**Comments on the Draft ESR
North Yonge Street Corridor Public Transit and Associated Road Improvements**

**Re: North Yonge Street Corridor Transit and Associated Road Improvements
Draft Environmental Study Report – Preliminary Comments
Our File No: T.30.13.3**

**Re: Response to first submission of entire DRAFT Environmental Study Report (ESR)
Municipal Class Environmental Assessment – Transit – Schedule C
Yonge Street Transit and Road Improvements
Gamble Road/19th Avenue to Bloomington Road
Humber River and Rouge River Watersheds
Town of Richmond Hill; Regional Municipality of York**

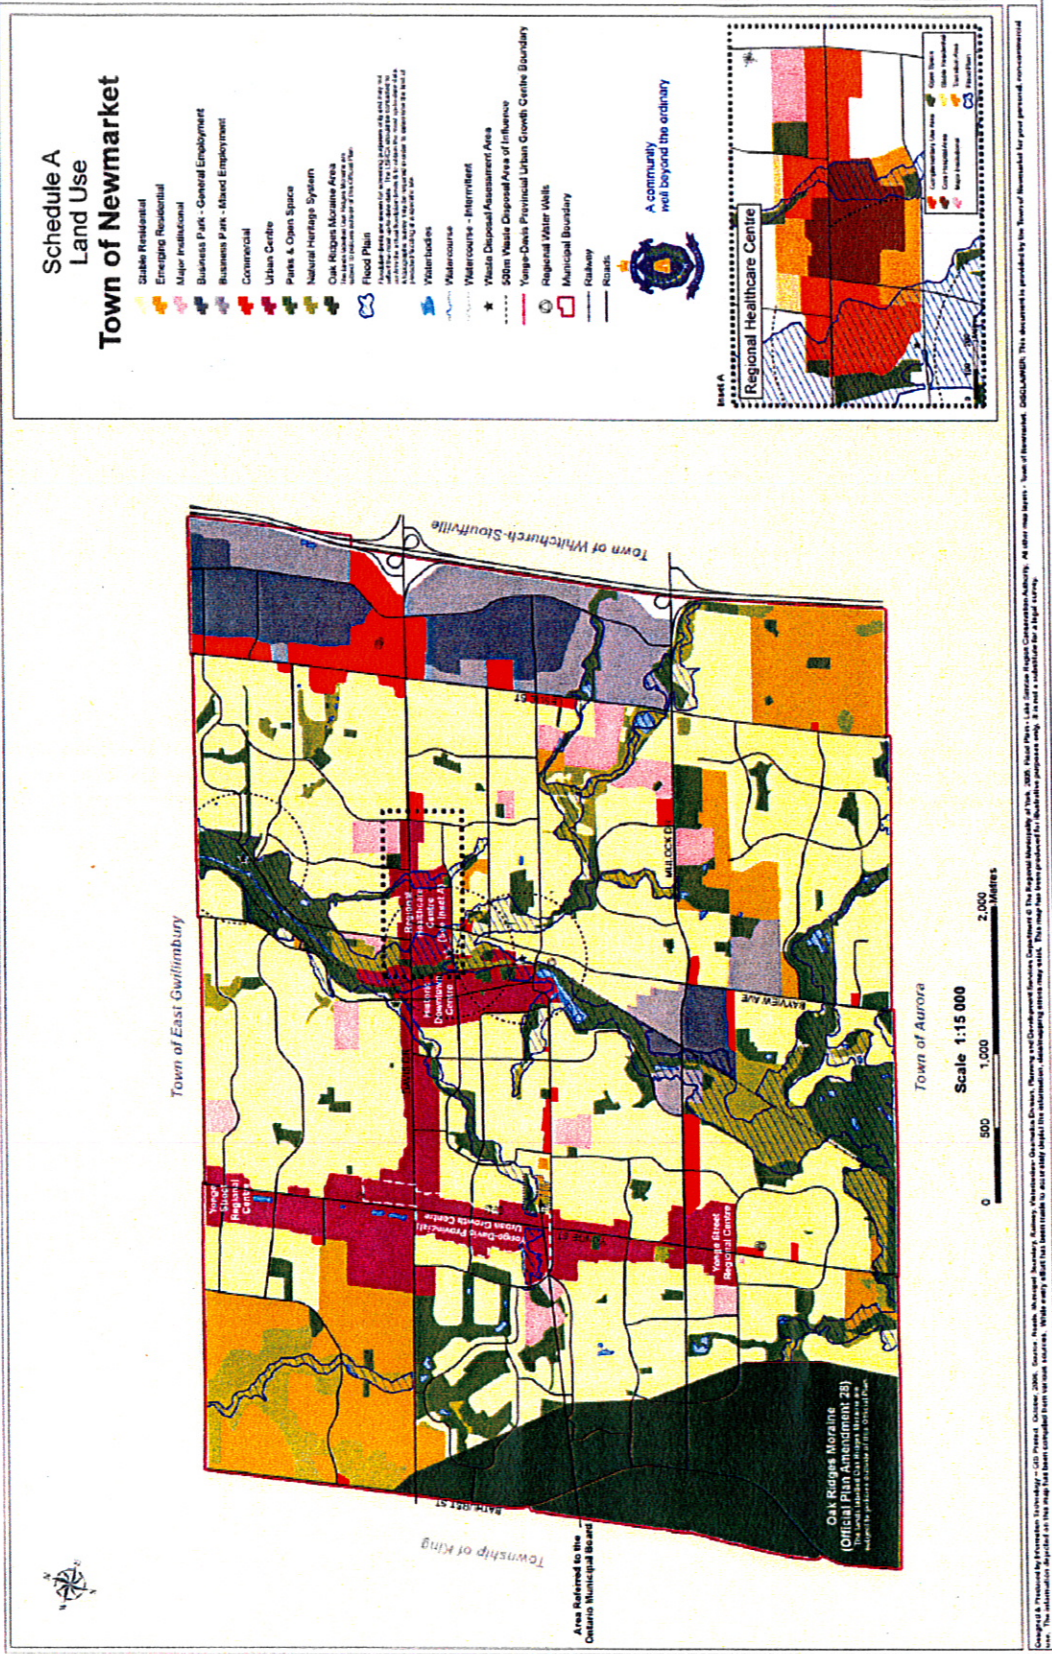
4. Section 10-1, page 10.1. The text indicates that there will be a station at Savage Road North, but Figure 10-1 and the subsequent design plates indicate a station at Savage Road South. This should be corrected.
5. Figure 3-6, page 3.7. The Land Use Plan is not the final approved Schedule "A". The correct version is on page 3 of this letter.

Comment #	Agency and Representative	Comment	Response/Action
1	Town of Newmarket, Rob Prentice and Rick Nethery	<p>a) Section 2.3.1, page 2.4: The text refers to the widening of Leslie St. Currently, York Region is undertaking a Schedule C EA on Leslie St. with the first Public Consultation Centre at the end of this month. The widening is proposed for 2015, not 2011, as noted in the text. As well, the text seems to have some duplication re. Leslie St. This needs to be reviewed and corrected.</p> <p>b) Section 3.3.2.2, page 3.13: Under the screenline information, the text refers to the unfeasibility of widening Bayview Ave. through downtown Newmarket. Bayview Ave. does not traverse downtown Newmarket. Bayview Ave. becomes Prospect St. and goes through an older area of Town with limited road allowance for widening.</p> <p>c) Table 4-4 and other Tables: It appears when the preferred alternative is highlighted in blue, the responsiveness indicators (quarter circle) is not coloured properly, and come out white. This should be corrected as this does create confusion when reviewing the evaluation ranking.</p> <p>d) Section 10.1, page 10.1: The text indicates that there will be a station at Savage Road North, but Figure 10-1 and the subsequent design plates indicate a station at Savage Road South. This should be corrected.</p> <p>e) Figure 3-6, page 3.7: The land use plan is not the final approved Schedule A.</p>	<p>a) Text has been updated.</p> <p>b) Text has been updated.</p> <p>c) Comment noted. All of the responsiveness indicators have been made black for consistency throughout the ESR.</p> <p>d) Text has been updated. The station is at Savage Road South.</p> <p>e) Figure 3-6 has been updated with final Schedule A.</p>

Plate 10-85

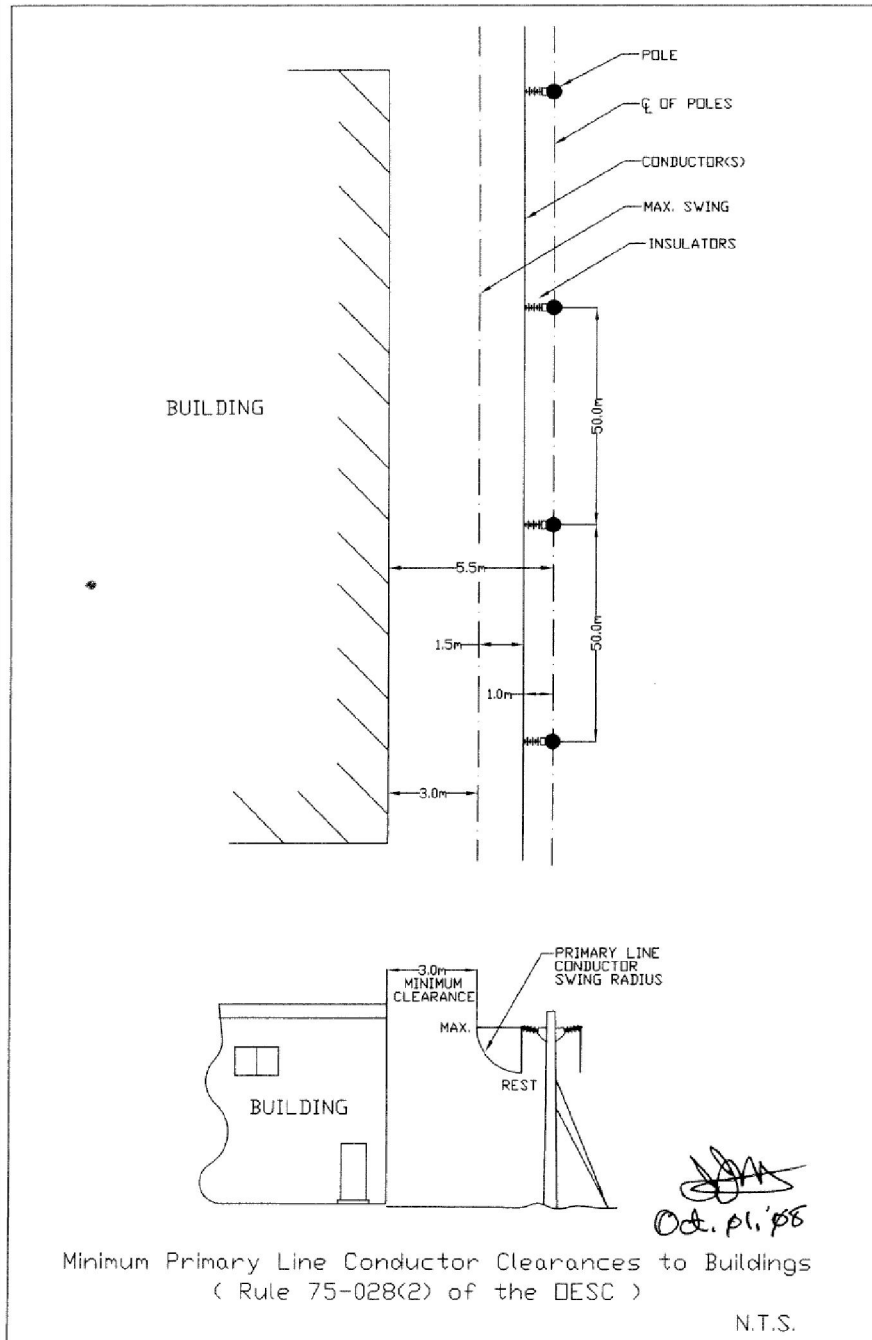
Similarly north and south of Davis Drive, and immediately west of both Bayview Parkway, Charles St, and Lundy's Lane, we are concerned that road widening and the necessary power transmission line relocation will cause a conflict with those properties. The transmission lines will need to be set back from the curb, but will also require a clearance of 5.5m from the centreline of the poles to any property higher than one storey. This could therefore require undergrounding of the transmission lines and requires further investigation. It is understood that through the hospital corridor transmission lines are undergrounded in any case, and so should not be affected.

The potential for similar conflicts and the need for undergrounding must therefore be reviewed all along Davis Drive,
